## Zoning and Platting Commission Question and Answer

B-2

Questions Commissioner King

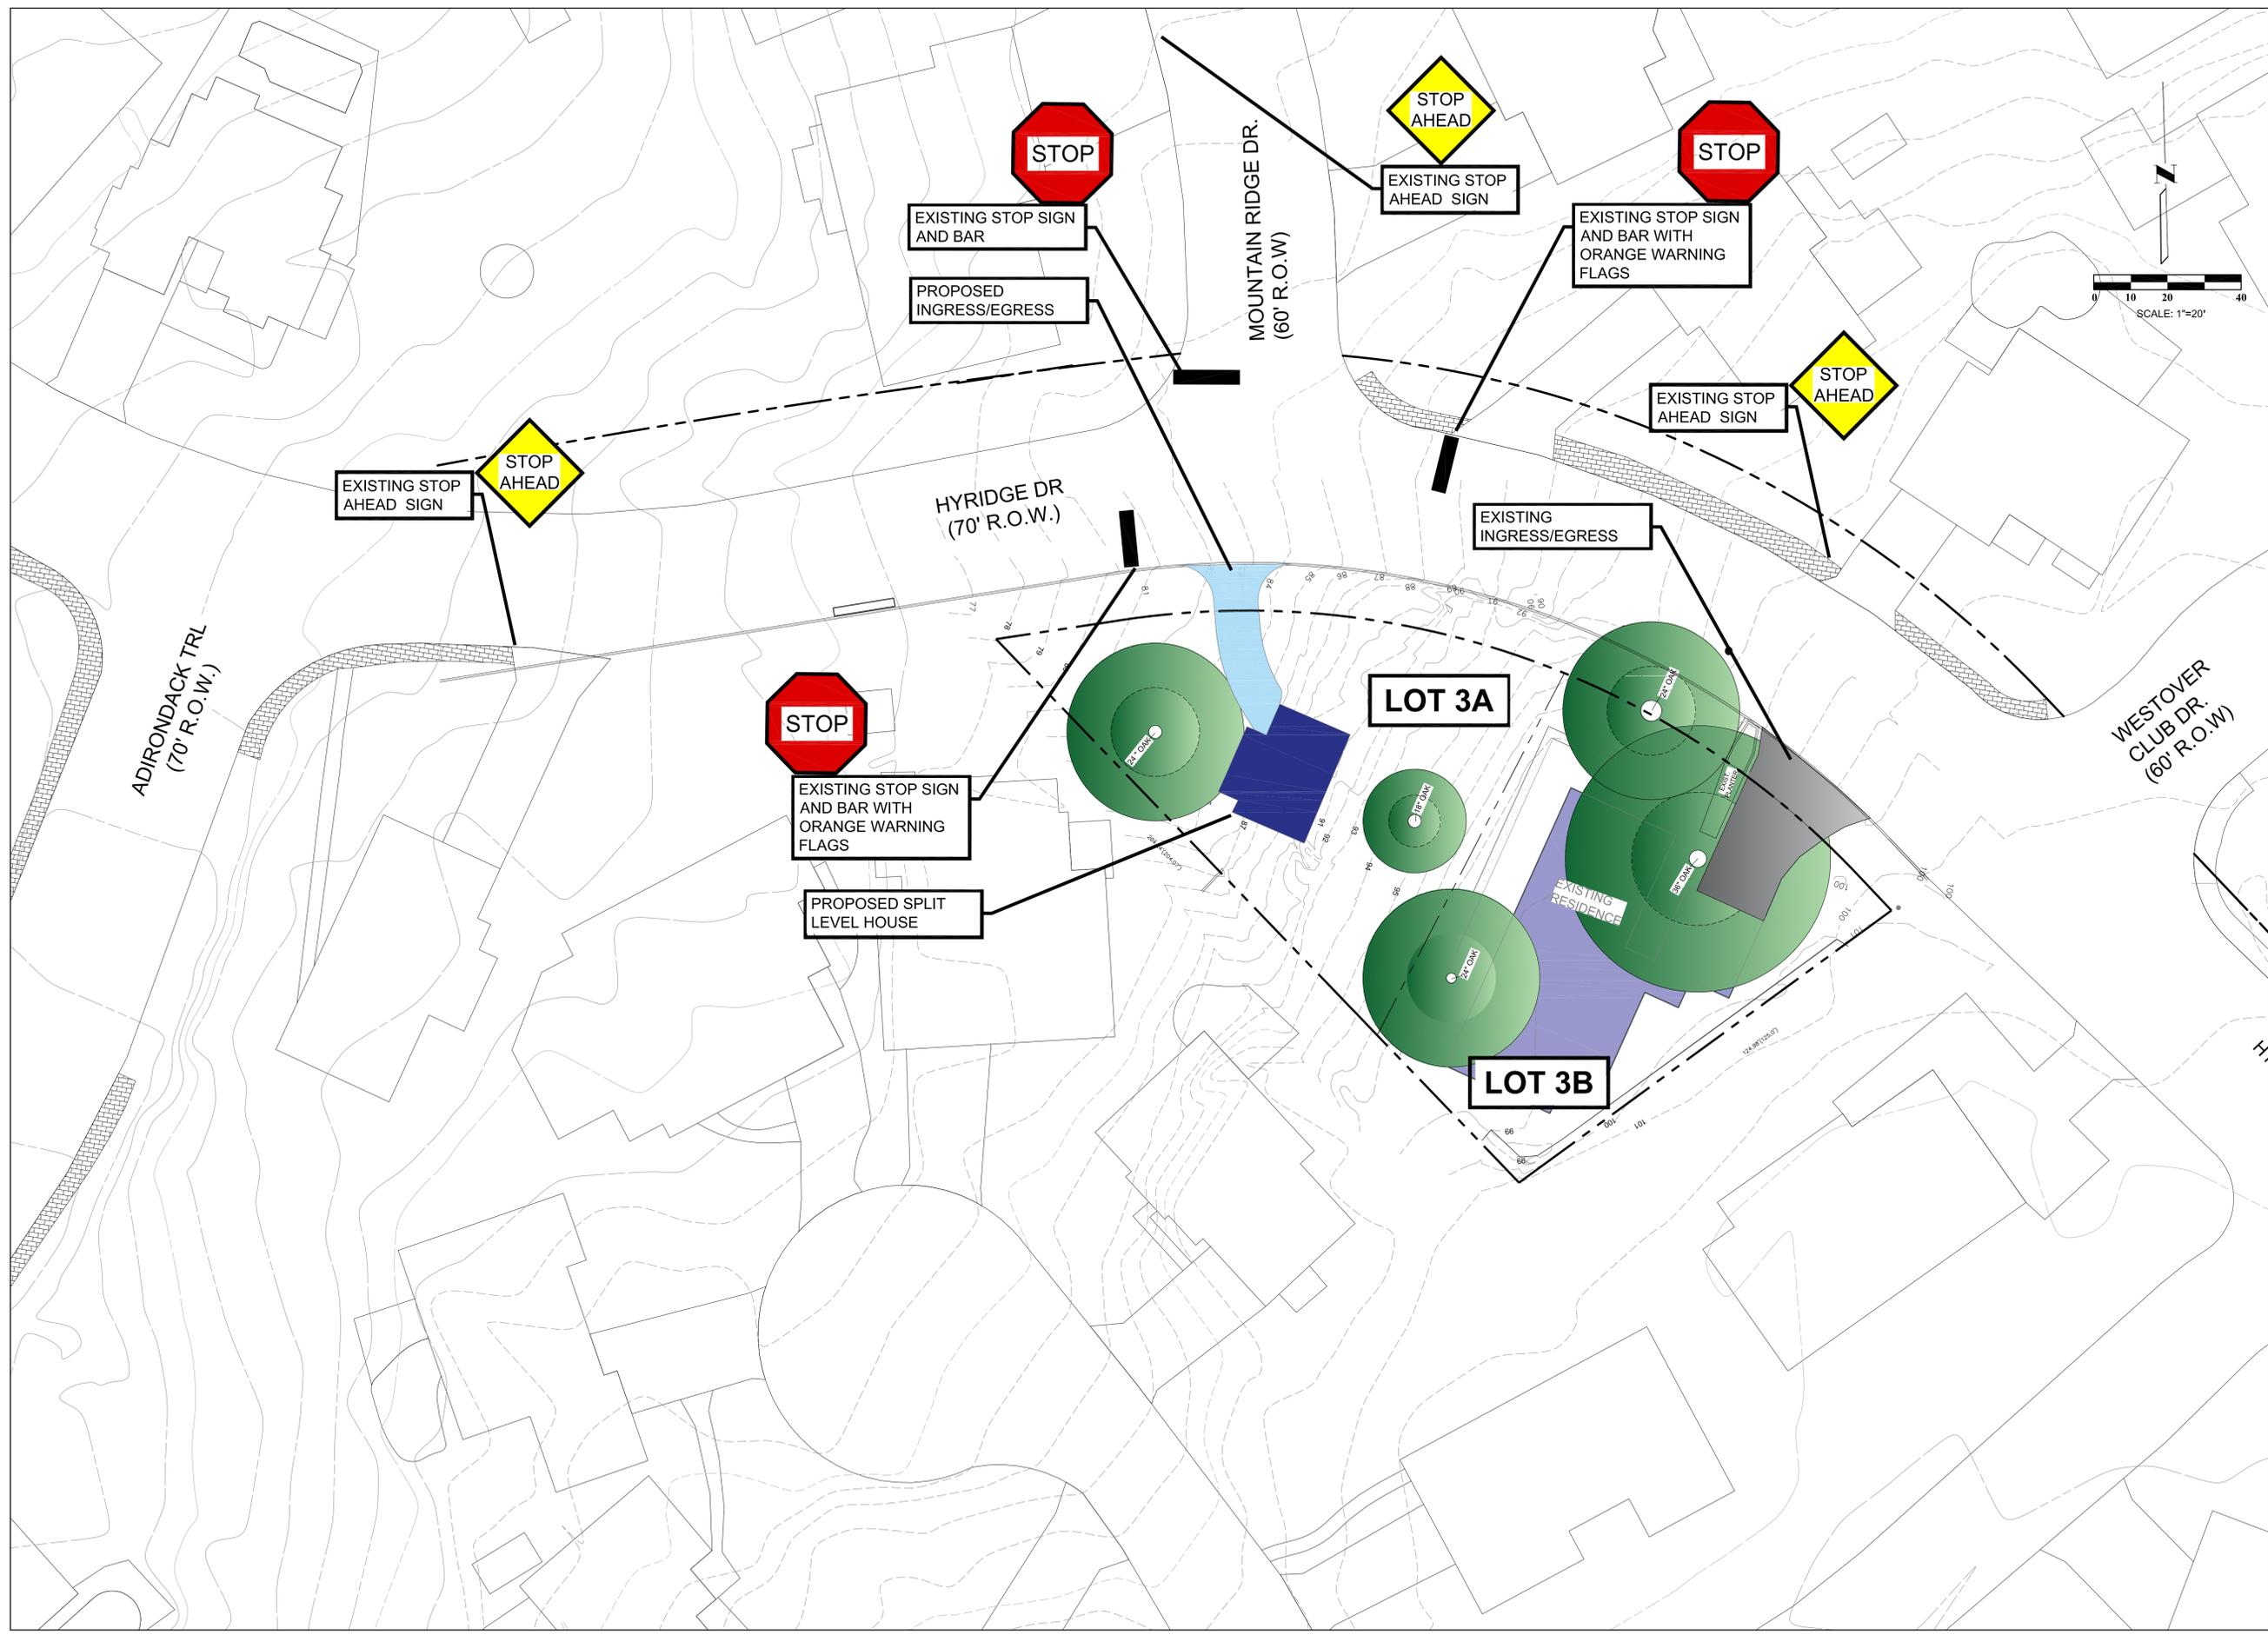
I've attached a screenshot of a portion of Amber Mitchell's memo when ZAP voted to disapprove in 2010. In it she states that the applicant offered to grade the subdivision to improve sight lines although this would require removal of a then 24" live oak. I assume removal of the tree would still be required to provide driveway access to the lot. Where can I find the tree survey? I would be happy with one from 2010.

I assume we can include the same conditions Mitchell proposed in 2010, that is, require a hammerhead driveway so that drivers don't back into the street.

The case reviewed in 2010 included a variance for which recommendation for the approval of the variance could be made by staff. The variance could then be approved with conditions placed by the commission as part of the recommendation. Other requirements or conditions can be placed on variance by a commission.

This case does not include a variance, and conditions could not be place on the plat.
